**MI&CT ESERVICE NOTE
SN07011917a**

Date: February 7, 2007

Subject: Performix Ultra, ADV, NP++ X-ray Tube - New Pump

Effectivity: All Performix Ultra, ADV, and NP++ X-ray Tubes

See picture below for example of previous and current oil pumps:

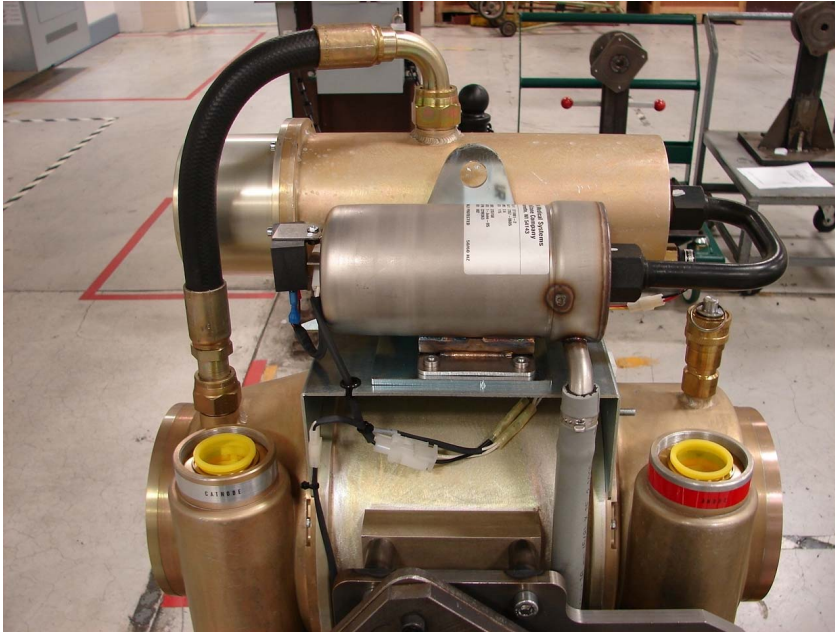
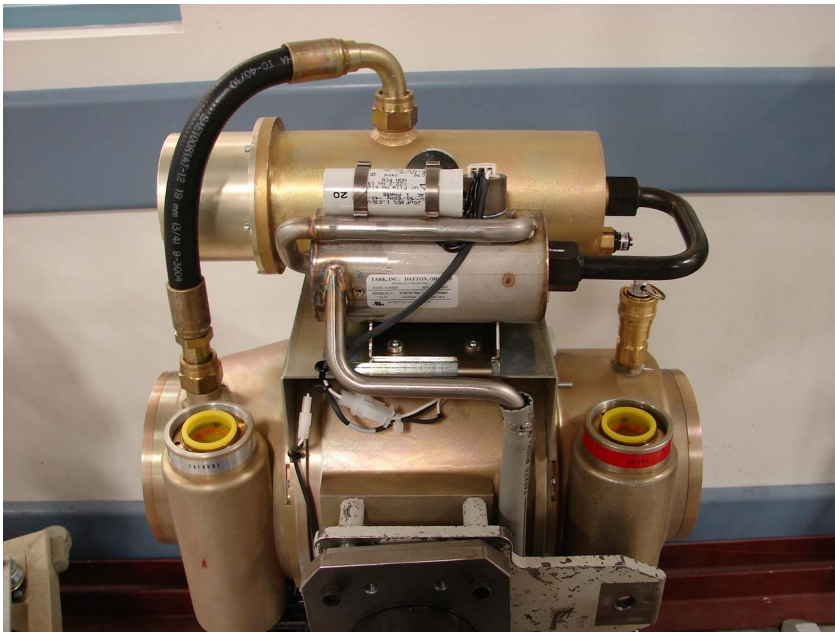
Details: All Performix Ultra, ADV, and NP++ X-ray Tubes have begun shipping with new dual impeller pumps and filters. The new pump design is a reliability improvement. The 2 impellers reduce load on bearings and thus increase reliability. The filter is internal to the tube and will help maintain dielectric oil strength over life by removing particulate from the oil.

No tube form, fit, or function has been changed. This will **not** affect field service replacement procedures. The new filter is **not** field-replaceable.
